## Invitation to Bid: Construction Fire Station 49 Addendum 4 October 31, 2025

### **NCFRC Station #49 Precon RFI**

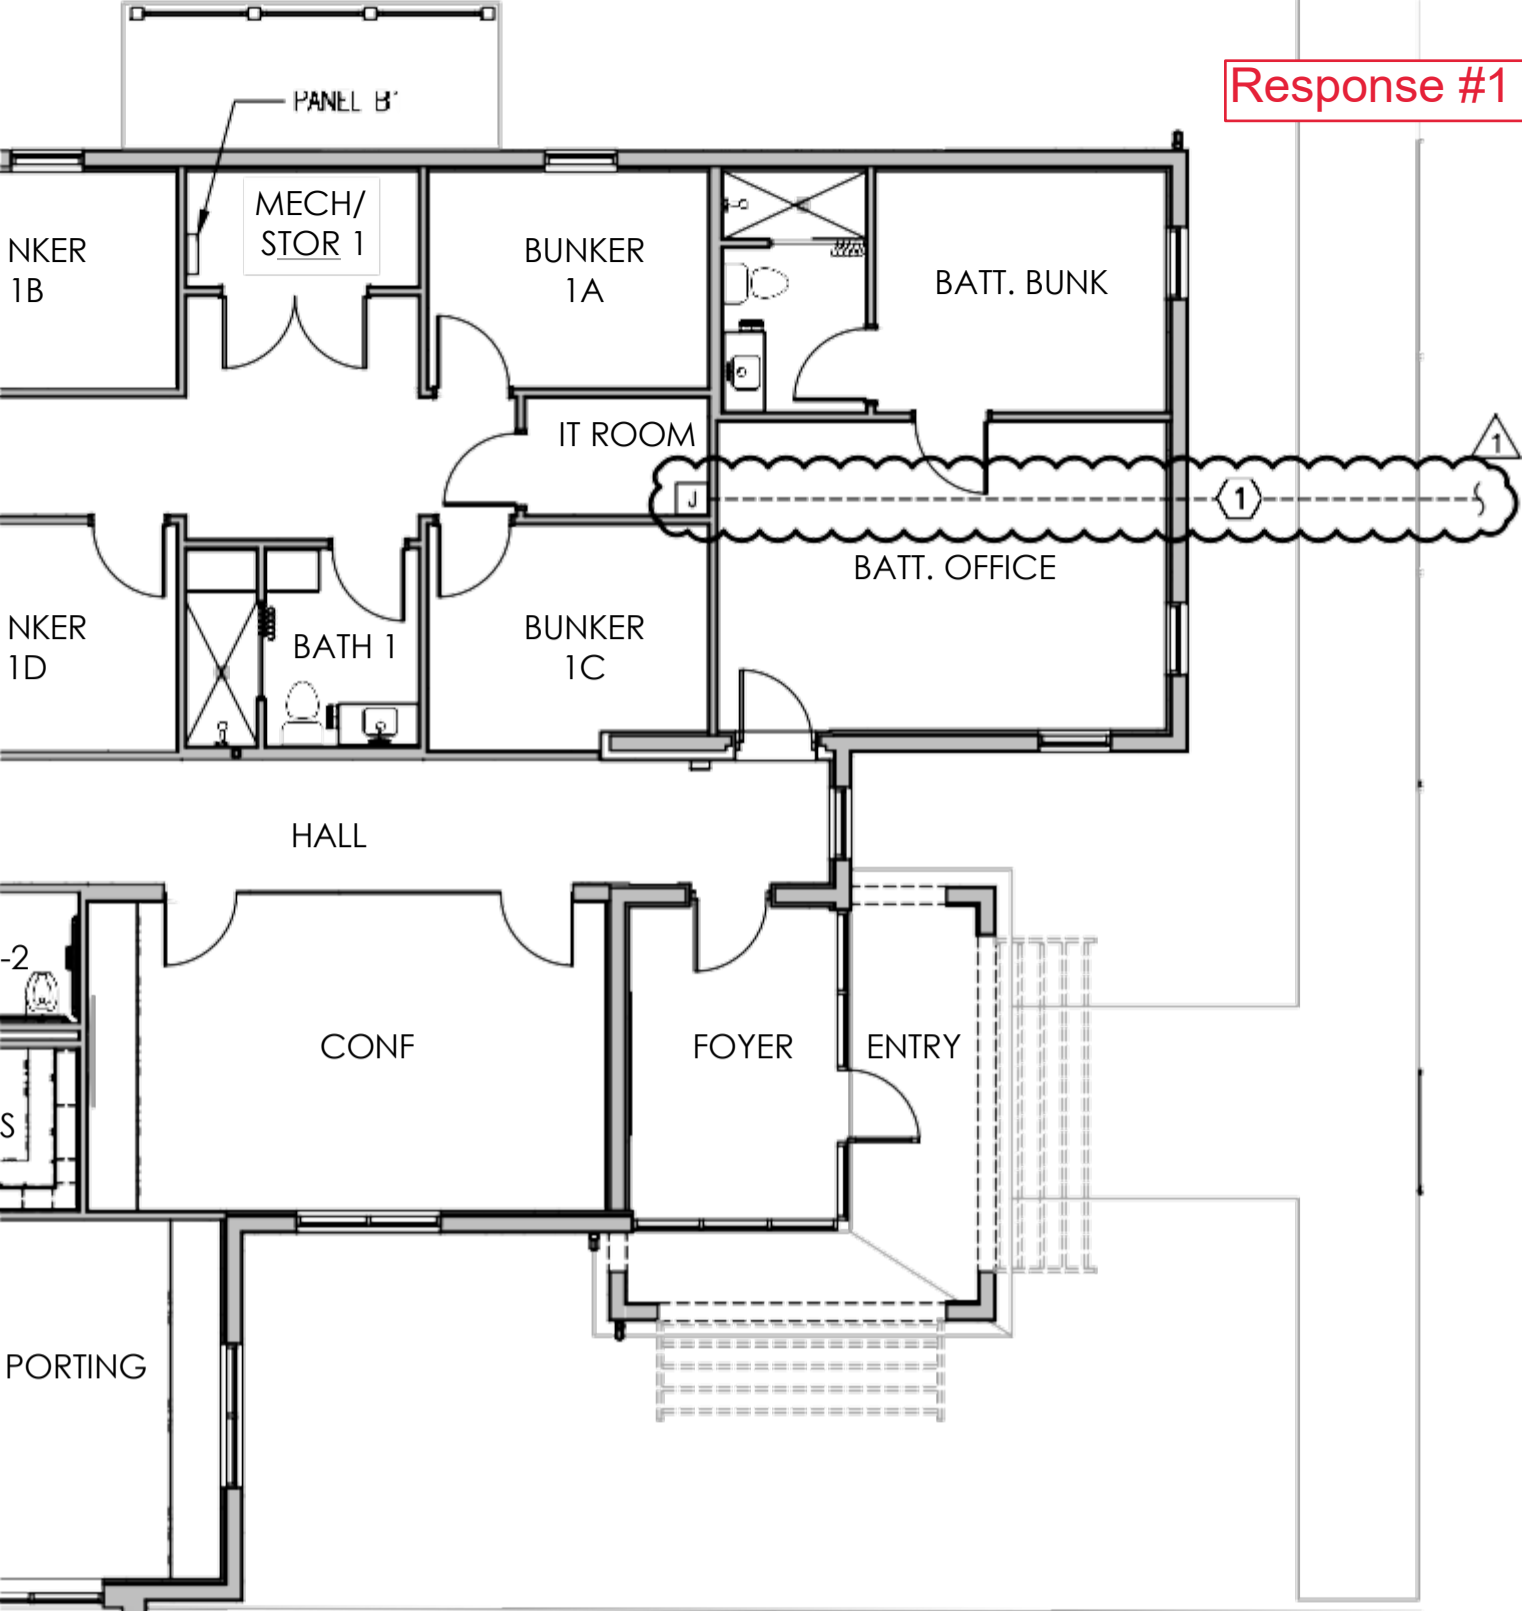
Elevation 1/A6.3 shows a curb less shower. Typical bathroom shower floors are recessed; please confirm whether these are to remain a step-down configuration with bullnose transitions to match the adjacent bathroom floor.

**Shower at 1/A6.3 is an ADA shower, so not step downs at this location.**

**E1.5**

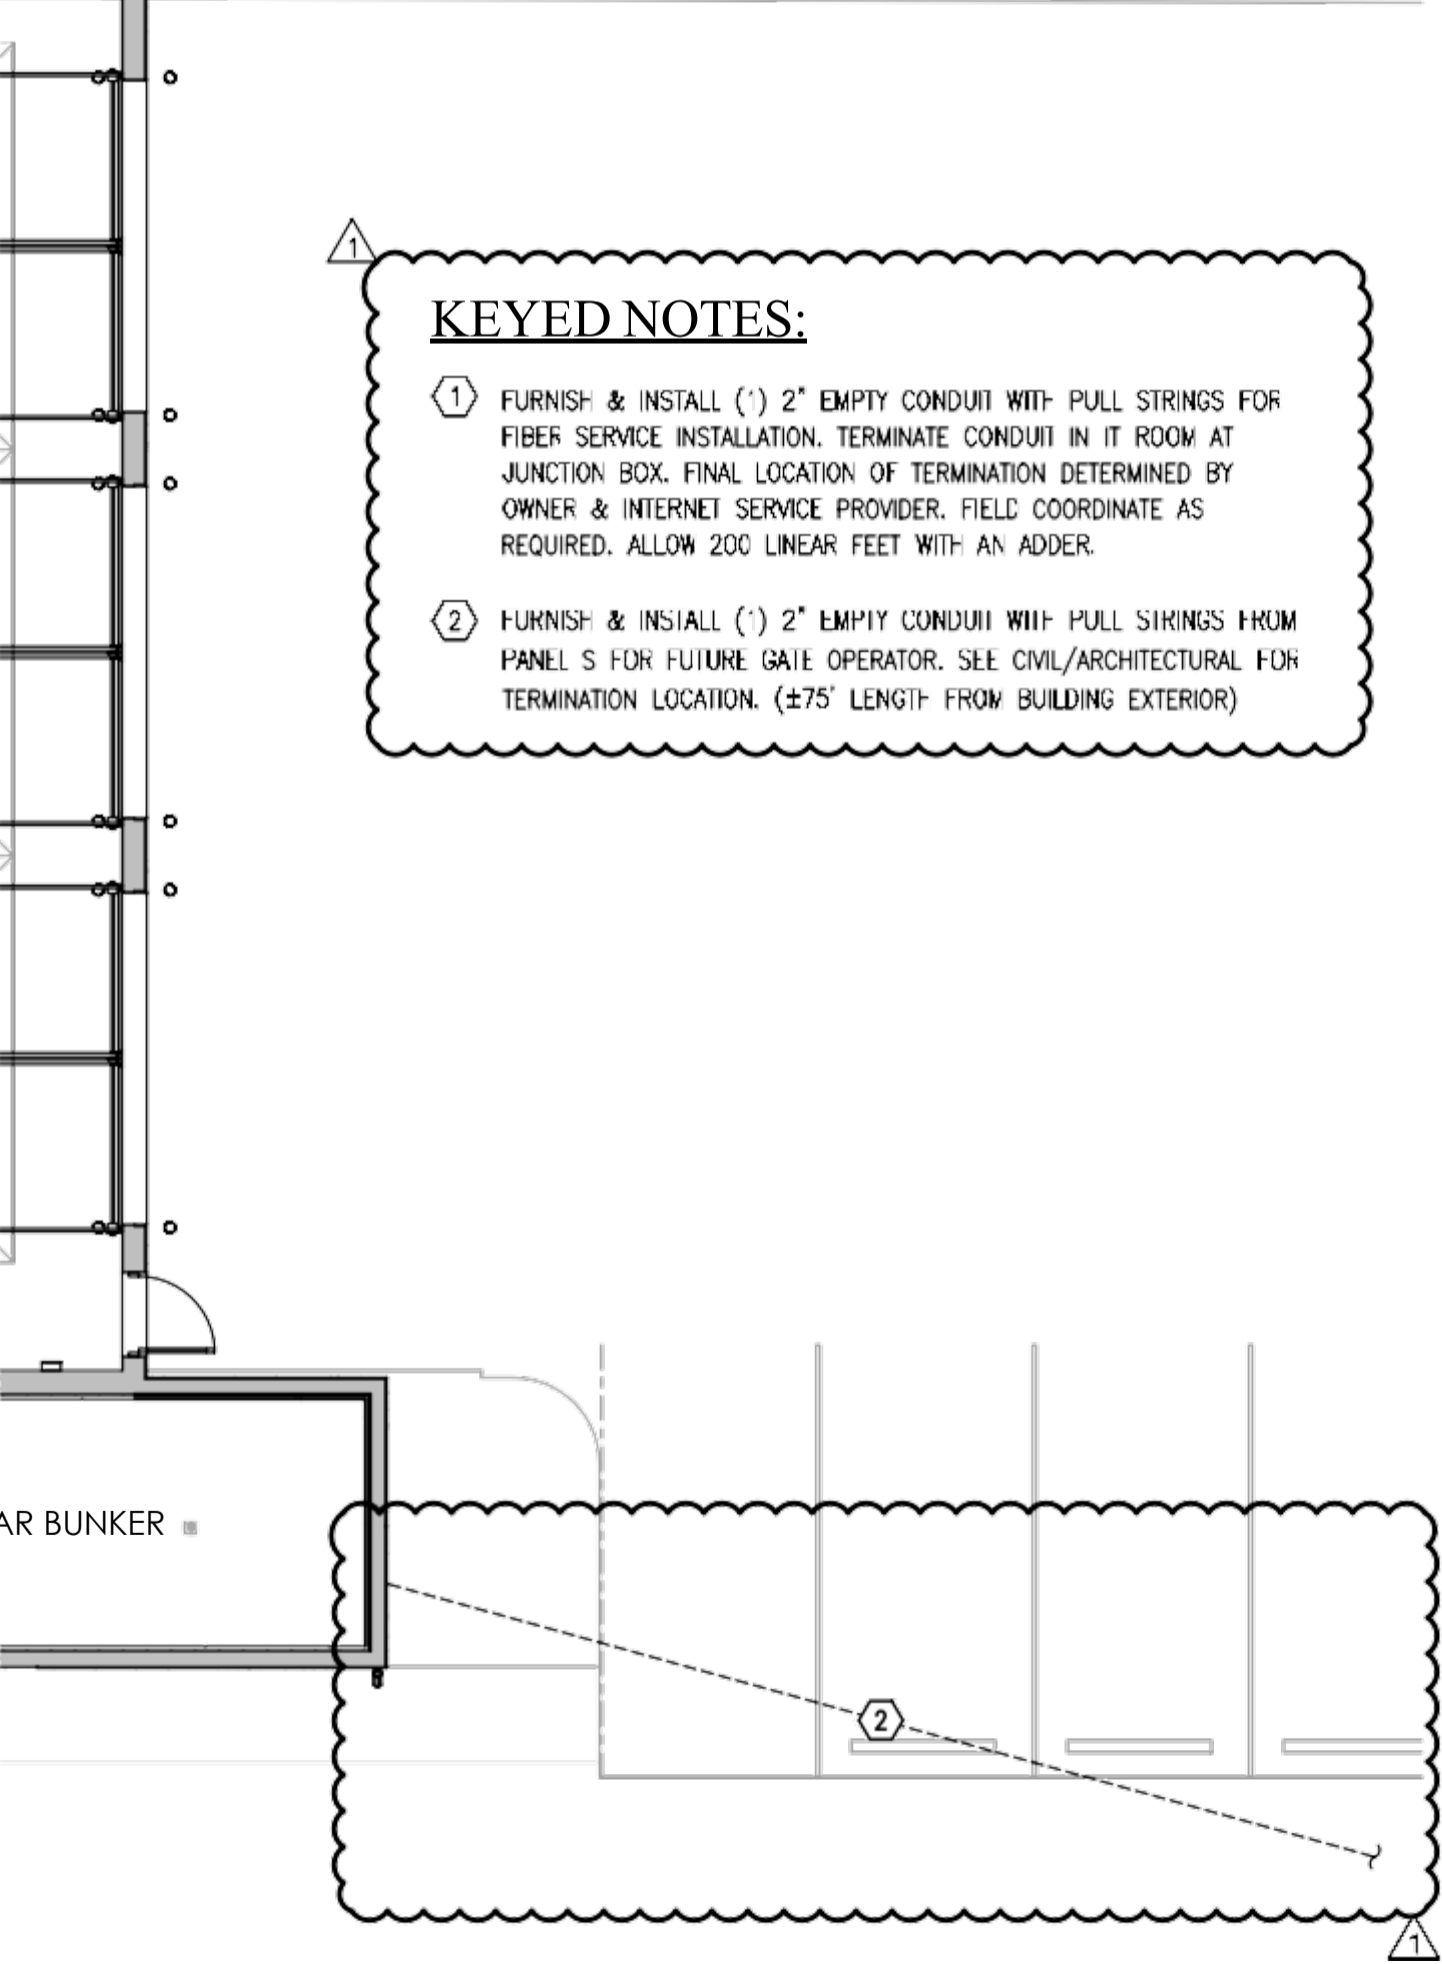
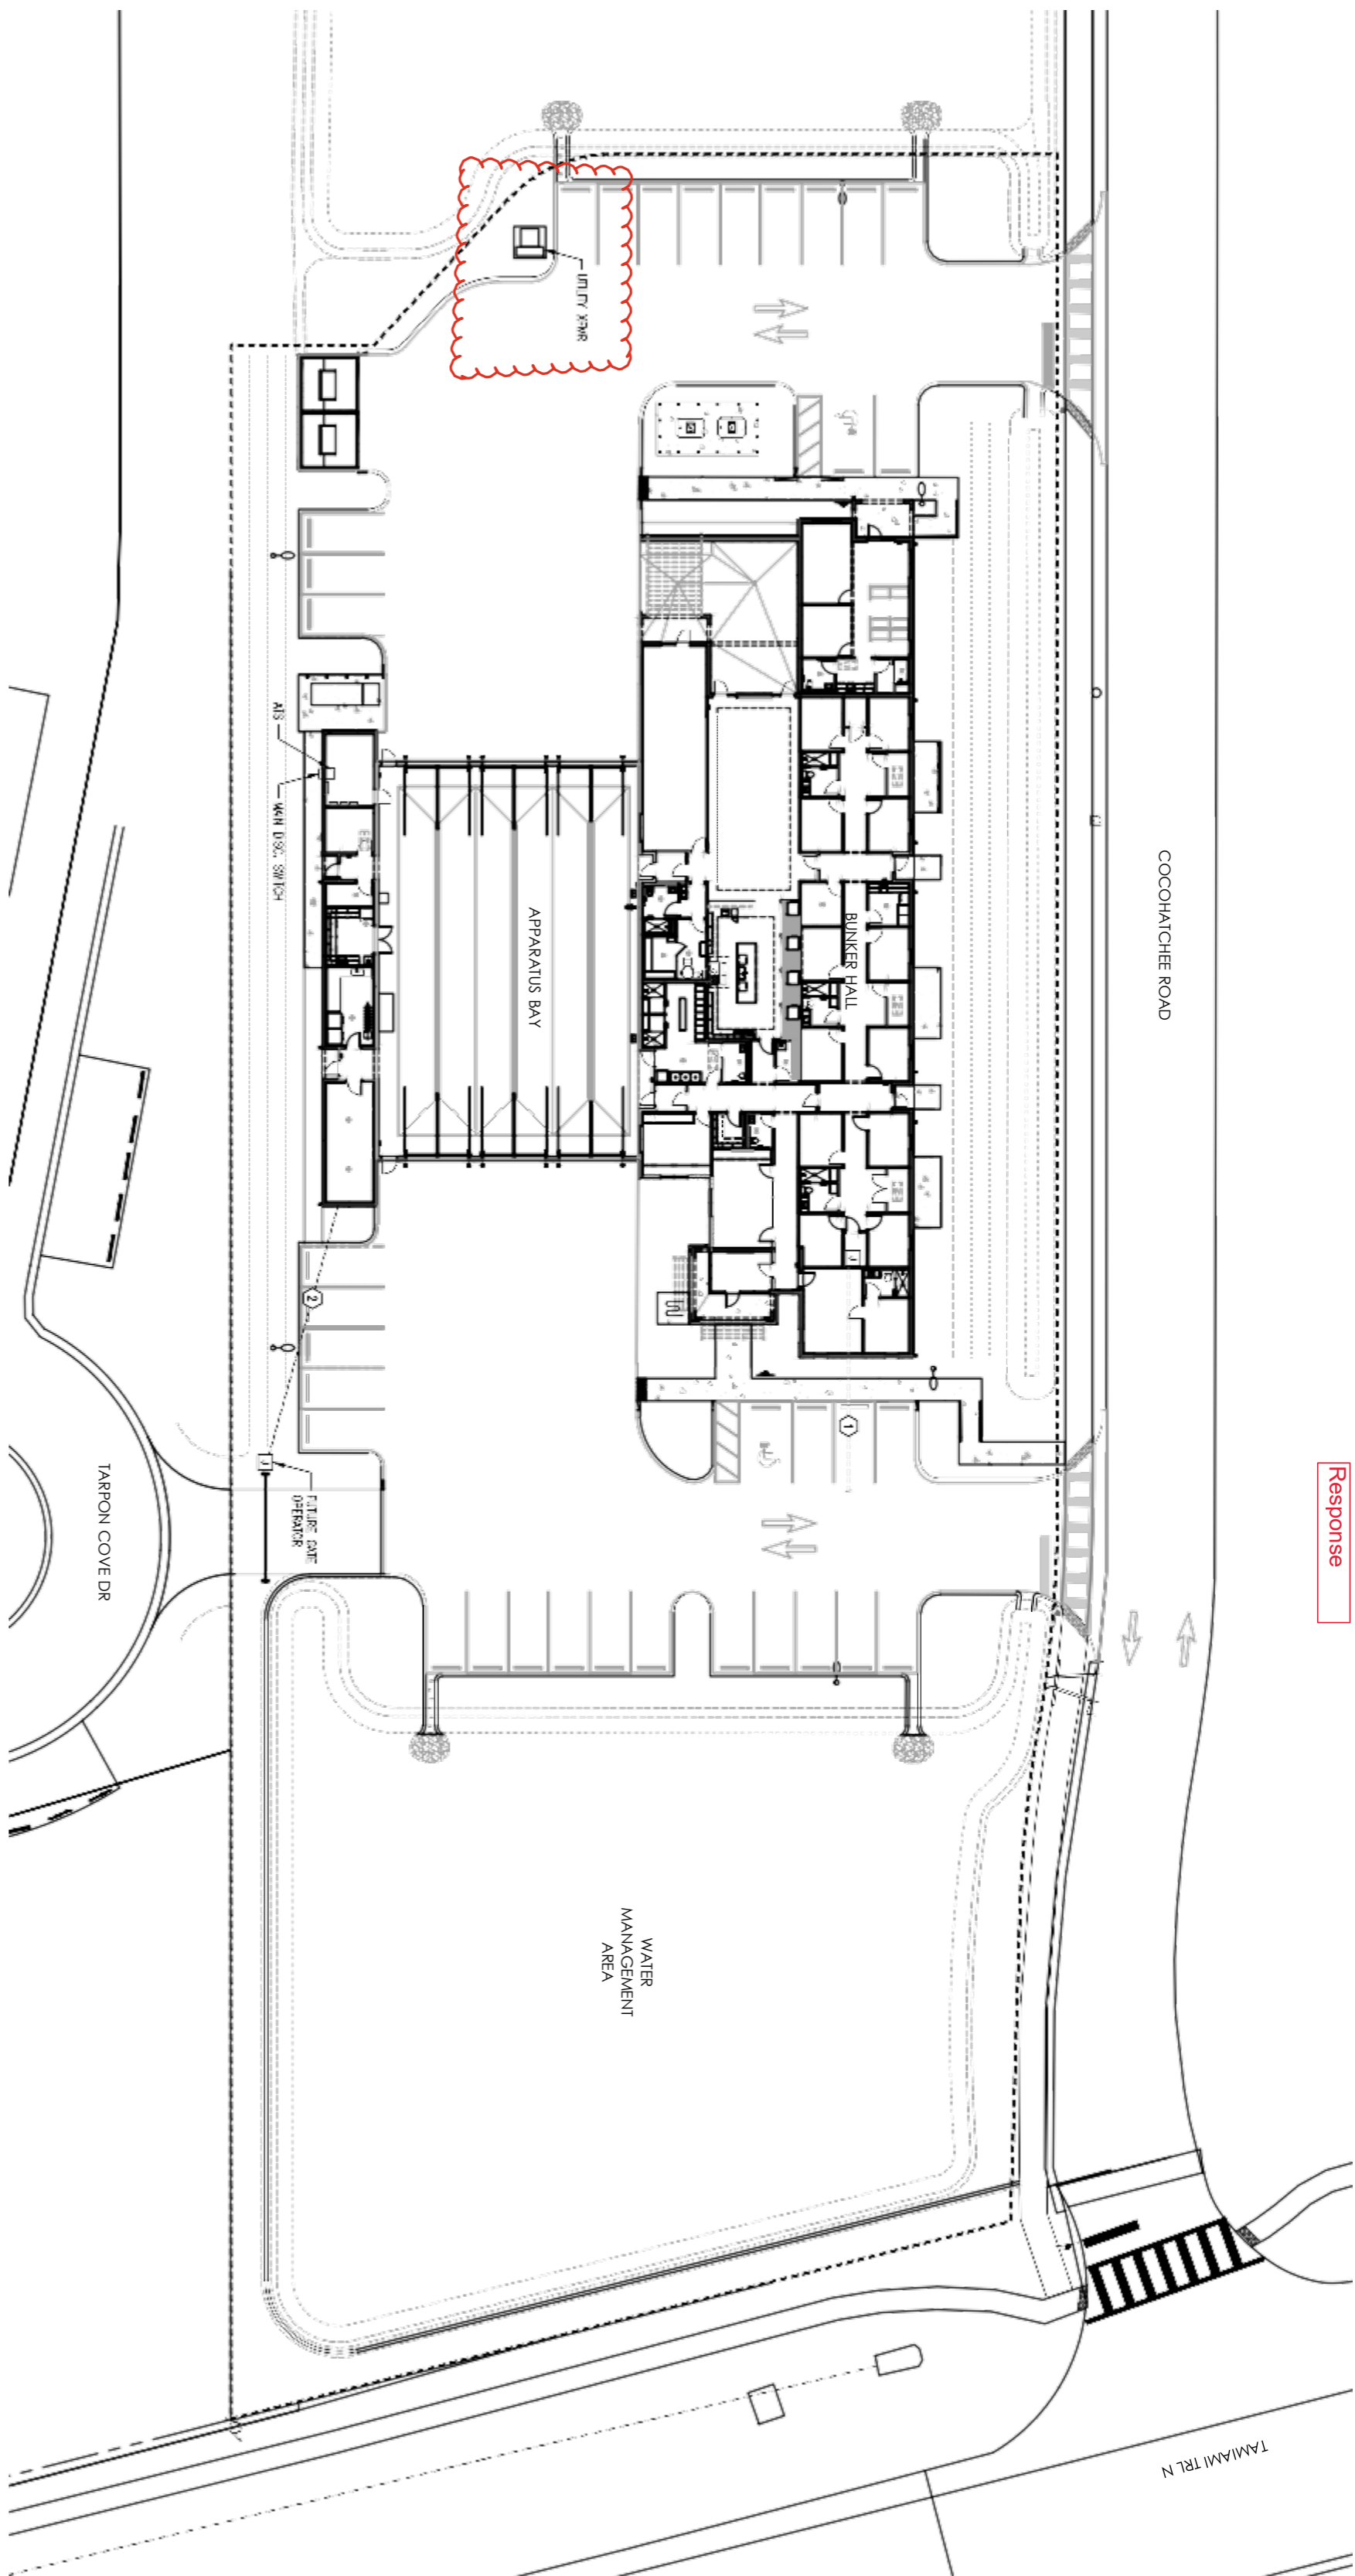
1. Print A1.1, overall Site Print, show a conduit to be installed from building to future gate location. This conduit is not shown anywhere but on this print and is not on the electrical set. Please indicate what size conduit and length for estimating purposes.

**See transformer location on attachment.**
3. Print E2.1 note #1 tells us to install (1) 2" conduit for incoming tele/data but civil prints and electrical prints do not indicate where we are running this conduit to. please locate ending point for this tele/data conduit duct bank.

**Conduit shall be 2" and extends approximately 75' from the southeast edge of the building. See attachment.**
2. Electrical Print E0.2 shows a Transformer with pad but Civil Prints and Electrical prints do not show a transformer with pad. Please indicate where the transformer is located and if we own primary conduit going to the transformer for utility connection. Locating the transformer is critical so we know how long our secondary duct bank is from there to the Main Service disconnect.

**Termination location needs to be coordinated with the internet service provider. Allow for 200 linear feet with an adder.**
4. Keyed Note #2 on Prints E1.2 States that certain lights shall automatically turn on in the event an alarm call is received. It states coordinate requirements with alerting systems. We need more information concerning this in order to include in estimate.
